Access Appraisal and Audit
for the
Cheltenham Art Gallery and Museum,

Access Appraisal and Audit.

Cheltenham Art Gallery and Museum

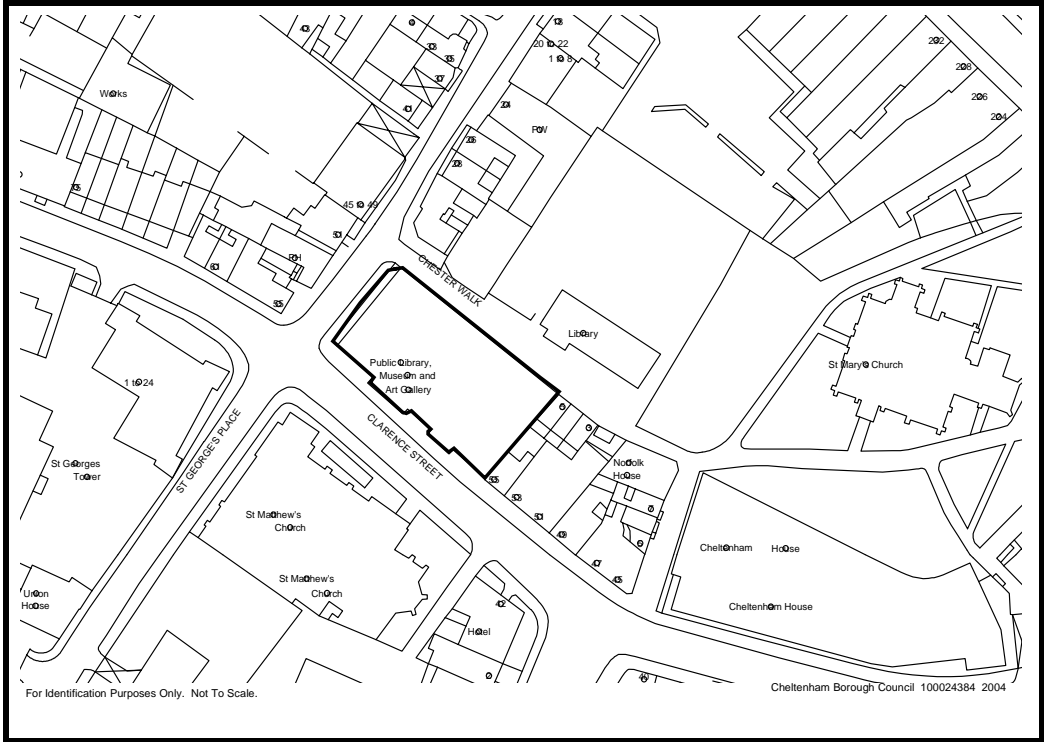
It is important to remember that this report can only be considered to be a 'snap-shot' of the current situation at the museum. The survey was carried out during a period where a major exhibition was being designed and constructed and whilst there were works being carried out on an adjacent commercial building which is situated on the corner of Clarence Street and Well Walk. These items have an impact on the ease of movement in and around the building.

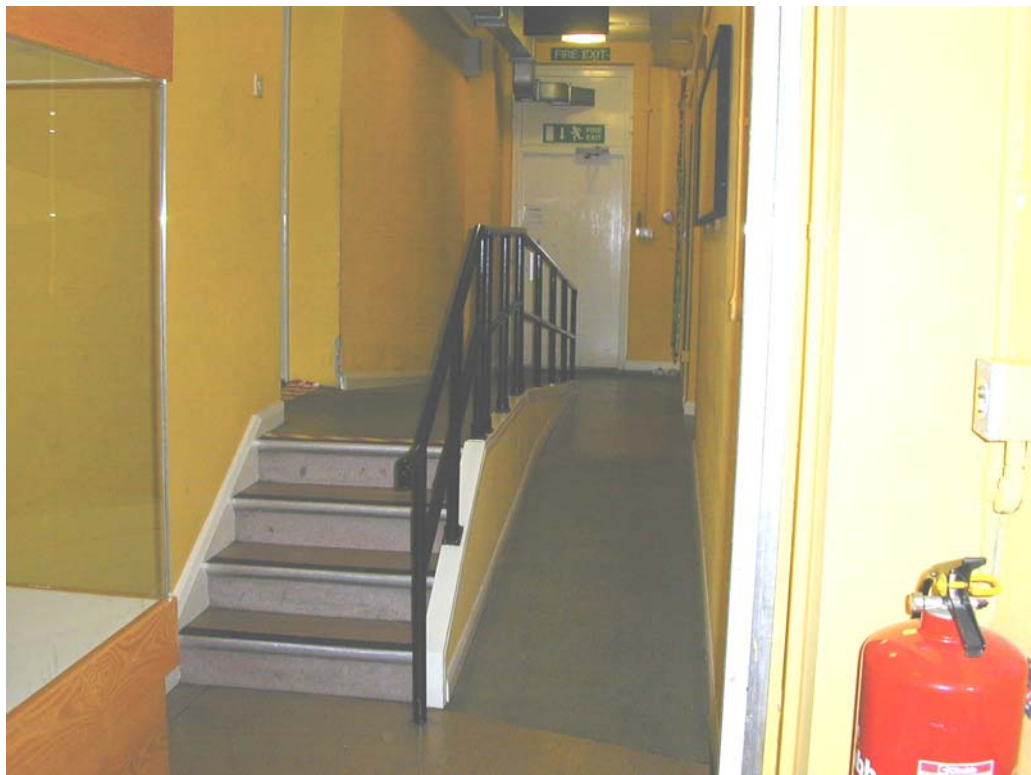
The reception desk does not adequately provide for wheelchair users. The top surface of the desk is 1100mm above floor level with an area reduced to 900mm above floor level, however, there is no provision for people to move close to the desk without banging their knees. Access to the desk from the service side is also not suited to people in wheelchairs. There is no induction loop facility at the reception desk.

Signage is limited but what signage there is of a reasonable standard. Wayfinding signage is limited and information relating to the exhibits is very hard to read for anyone with poor eyesight or who may have to read from a seated position.

1. Door opening mechanism to be reviewed with regard to the amount of effort required to open the door. If possible adjust the door to open more easily. This applies particularly to the main entrance, the café door and the meeting room door.
2. Improve signage particularly the style and positioning of signs which identify the position of the accessible WC facility.
3. Up-grade accessible toilet facility to conform to current good practice.
4. Provide induction loop for use in the reception area.
5. Review system of access to the building.
 - Review operation and design of lift
 - Review and adjust access route from the rear of the building.
6. Consider the provision of systems that would allow people with poor hearing or eyesight to use the facility. Large print signage or preferably the use of audio tapes linked to exhibit points.
7. Review the design of the reception desk facility.
